IOWA DOT Highway Division

STANDARD DESIGN - 40' ROADWAY, 3 SPAN BRIDGES

BEAM PLAN AND ELEVATION 320'-0 BRIDGE

RS40-079-14

BEAM ELEVATION

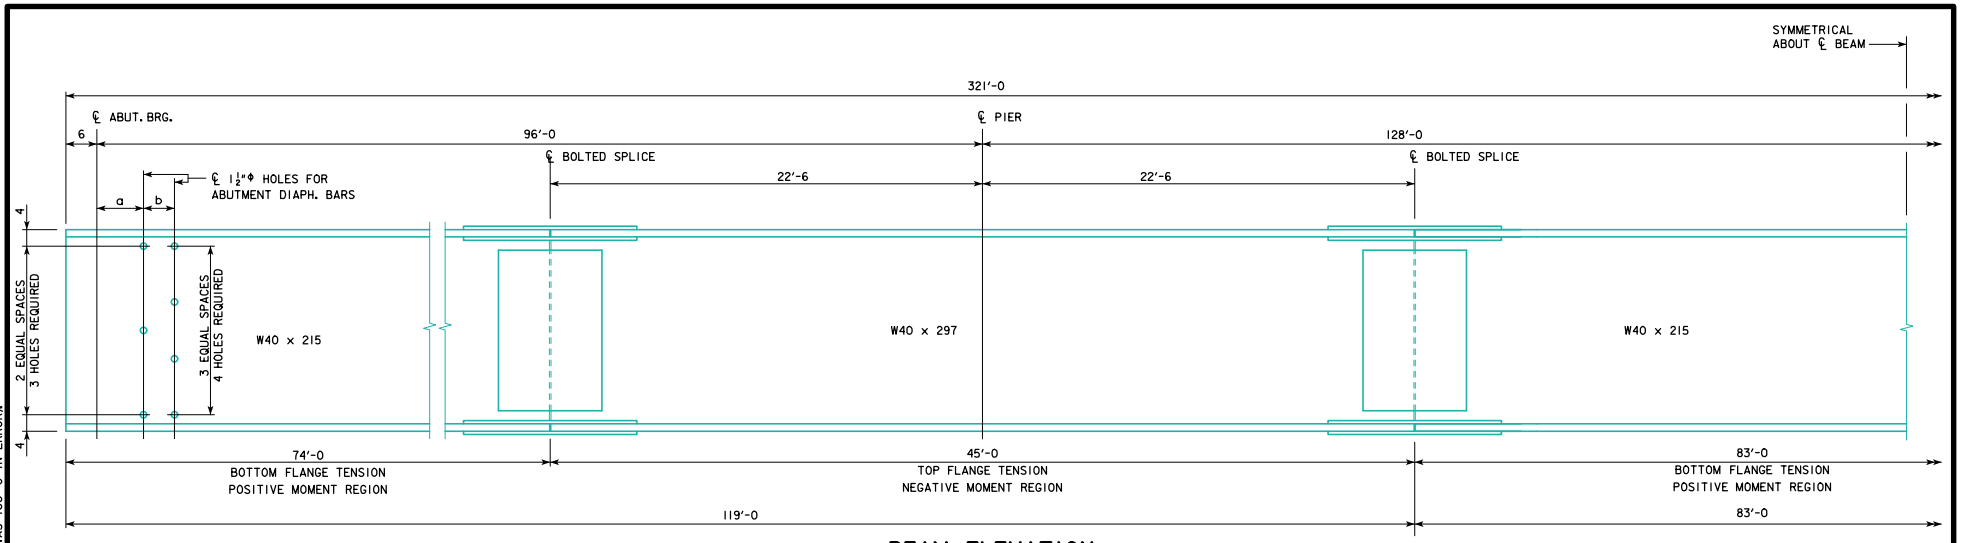
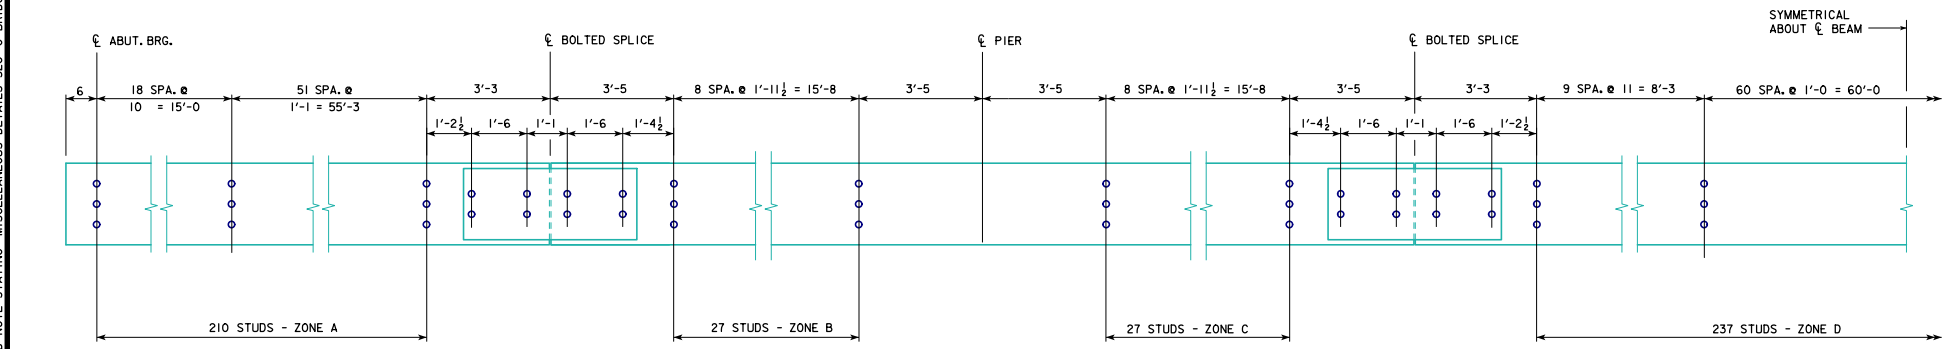
REVISED 02-2017 - ADDED 8 SHEAR STUDS AT EACH "CENTERLINE OF BOLTED SPLICE" LOCATION BETWEEN "ZONE A & B" AND "ZONE C & D". ADDED "SHEAR STUD ON SPLICE PLATE DETAILS" SHOWING 2 STUDS PER ROW. CHANGED NOTE STATING "MISCELLANEOUS DETAILS 320'-0 BRIDGE" (WAS 160'-0 IN ERROR).
